**ADDENDUM NO. 01  
October 24, 2022**

**BALES INTERMEDIATE AND WESTWOOD ELEMENTARY RENOVATIONS ISSUE FOR  
PROPOSAL  
FOR FRIENDSWOOD I.S.D.**

Prepared by: PBK  
11 Greenway Plaza, 22<sup>nd</sup> Floor  
Houston, TX 77046-1104  
PBK Project No: 220083

M-101A

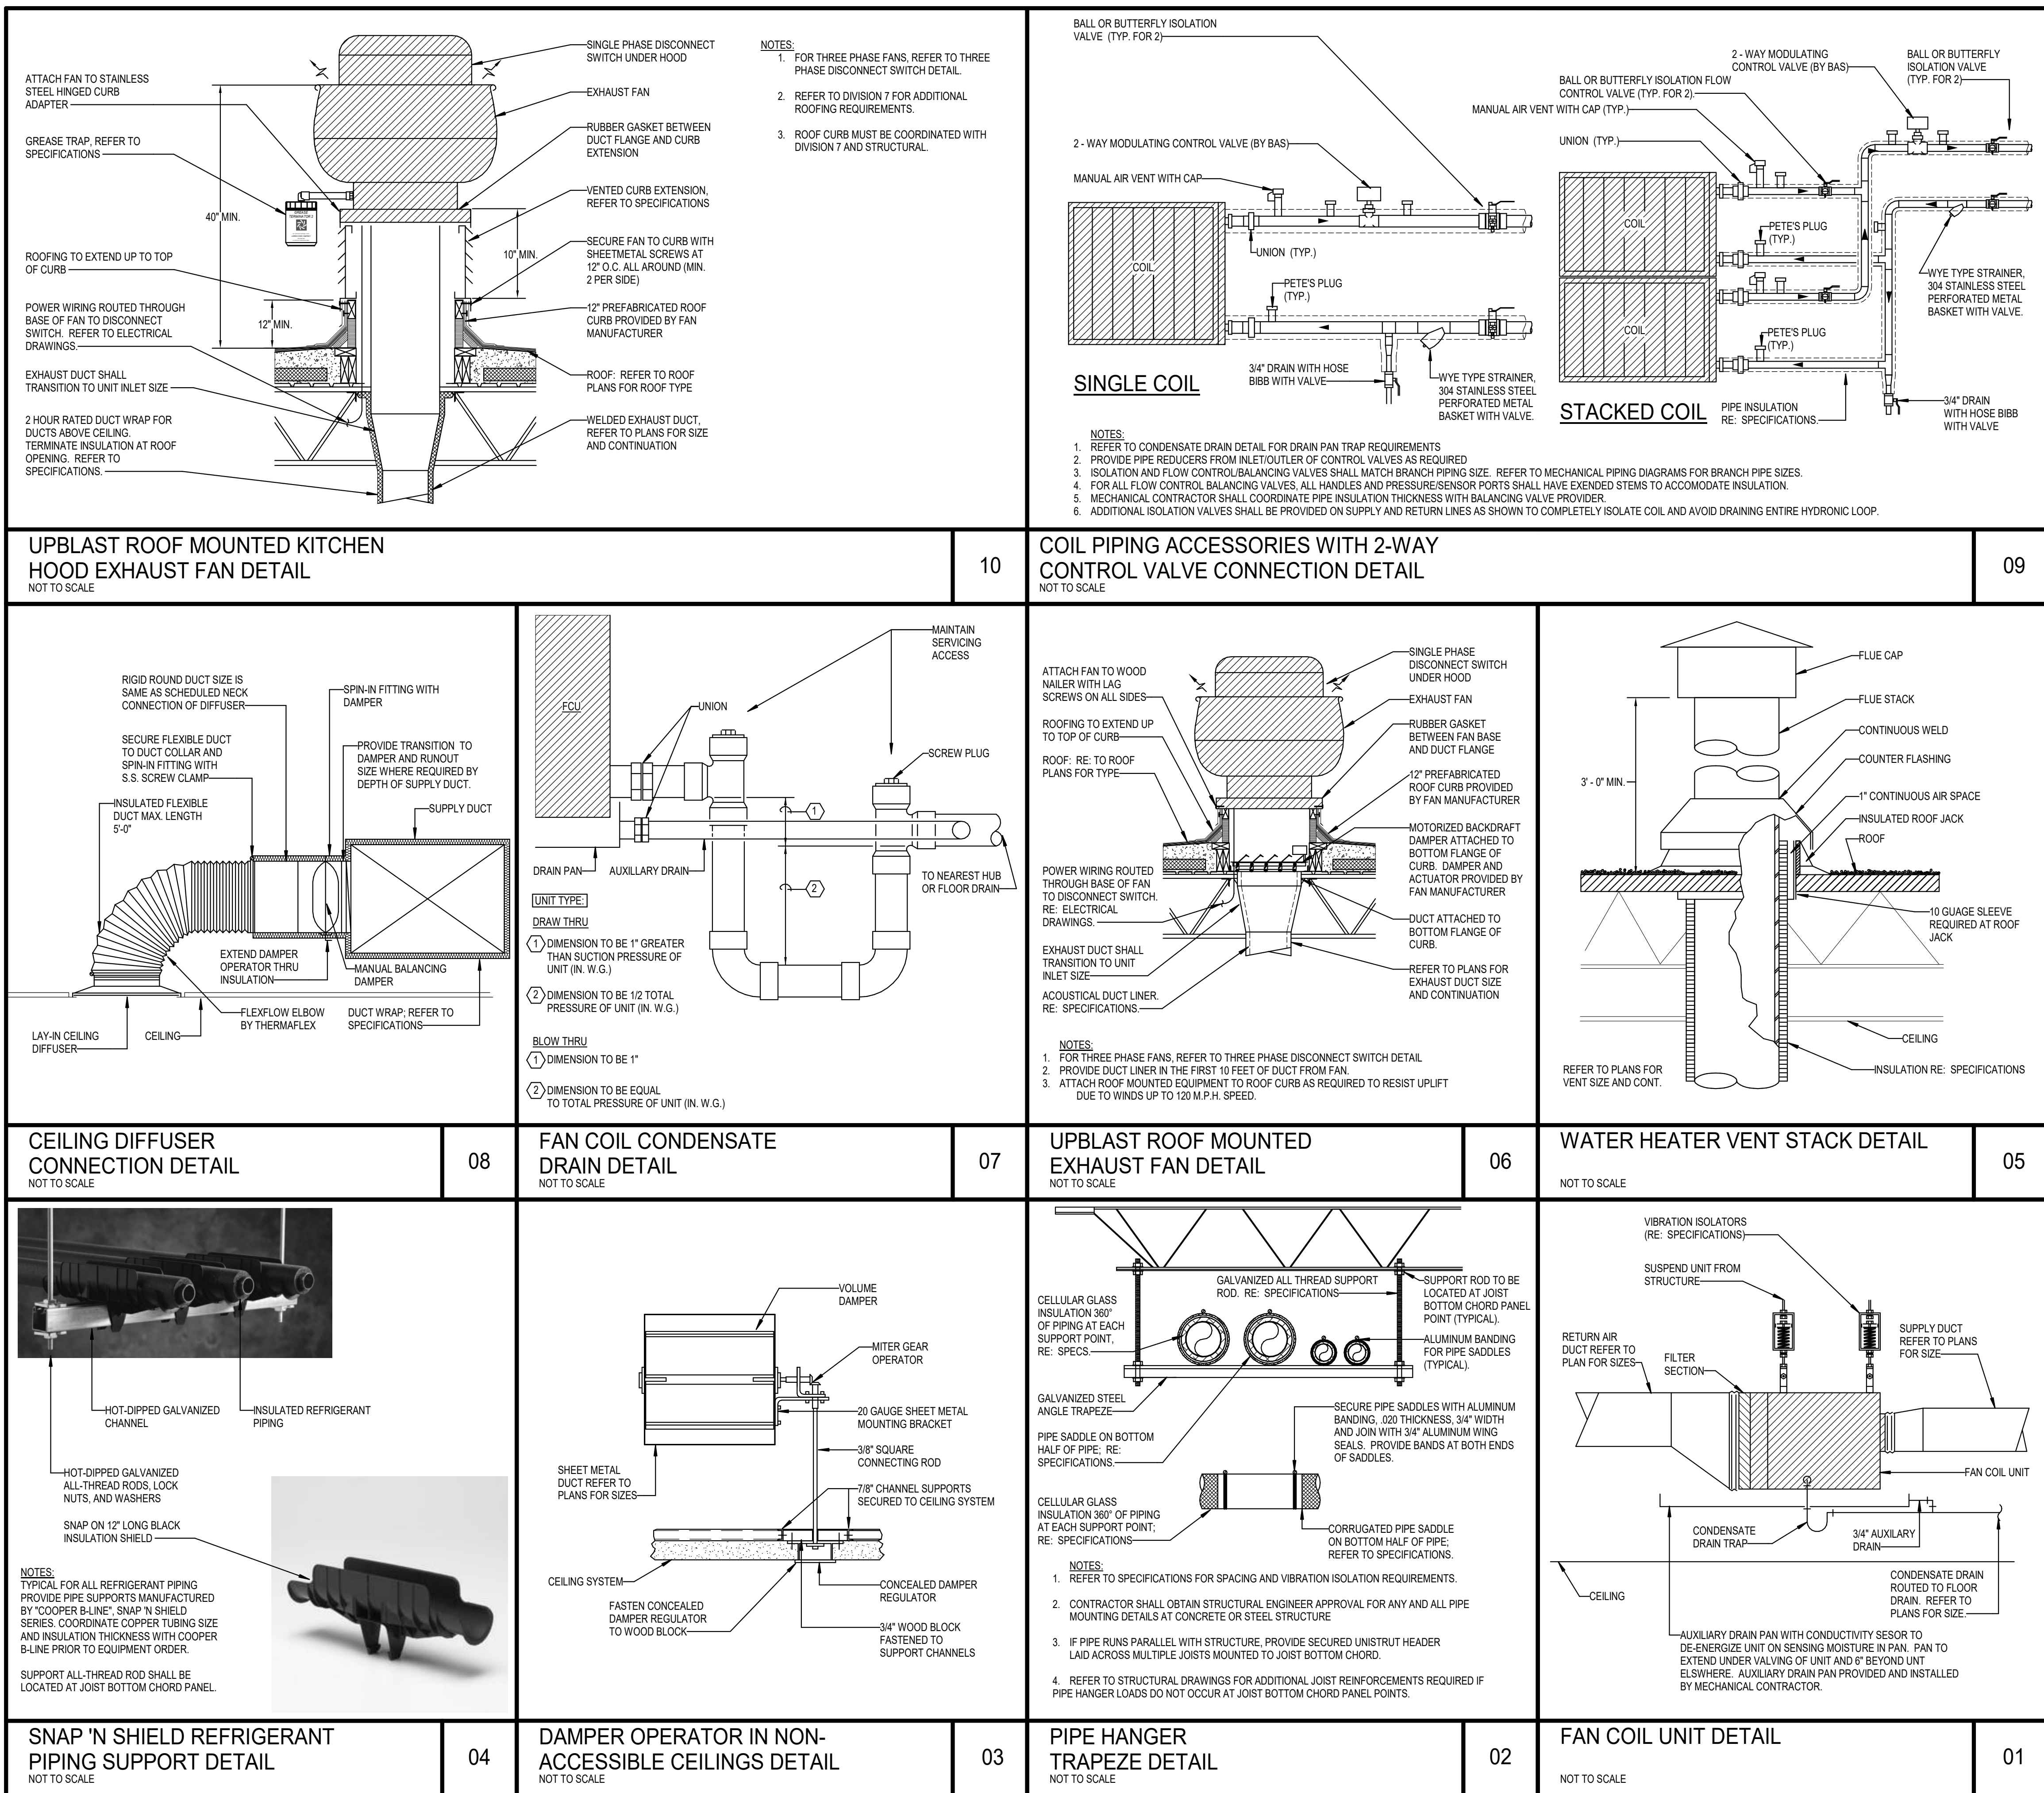
- Item No. 01     **SHEET M-101A – 1<sup>ST</sup> LEVEL - MECHANICAL PLAN – AREA A (Bales)**
1. Added keyed note 4: "Provide new motorized damper in existing duct work. Interlock with associated exhaust fan."

2. Added motorized damper symbol and keyed note 4 to EF-14 & EF-1 in Mechanical Room UE1 and the Boy's Restroom next to Storage Room B8 respectively.
